Palo Verde Nuclear
Generating Station

**Subject: Palo Verde Nuclear Generating Station (PVNGS)
Units 1, 2, and 3
Docket No. STN 50-528/529/530
Proposed Amendment to Technical Specifications
3.8.1, AC Sources - Operating and 3.8.2, AC Sources - Shutdown**

**Proposed Amendment to Technical
Specifications 3.8.1, AC Sources - Operating
and 3.8.2, AC Sources - Shutdown**

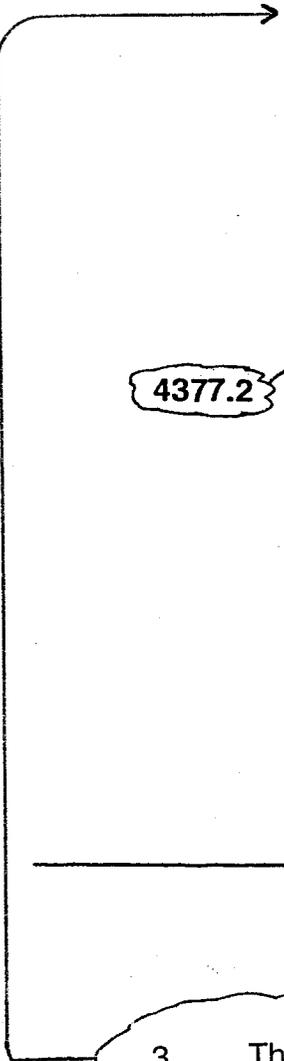
SURVEILLANCE	FREQUENCY
<p>SR 3.8.1.12 -----NOTES-----</p> <ol style="list-style-type: none"> 1. All DG starts may be preceded by an engine prelube period. 2. This Surveillance shall not be performed in MODE 1, 2, 3, or 4. <p>Verify on an actual or simulated Engineered Safety Feature (ESF) actuation signal (without a loss of offsite power) each DG auto-starts and:</p> <ol style="list-style-type: none"> a. In ≤ 10 seconds, achieves voltage ≥ 3740 V and frequency ≥ 58.8 Hz; b. Achieves steady state voltage ≥ 3740 and ≤ 4380 V and frequency ≥ 59.7 Hz and ≤ 60.7 Hz; c. Operates for ≥ 5 minutes on standby (running unloaded); d. Permanently connected loads remain energized from the offsite power system; and e. Emergency loads are energized (auto-connected through the automatic load sequencer) from the offsite power system. 	<p>18 months</p>

3. The steady state voltage and frequency limits are analyzed values and have not been adjusted for instrument error.
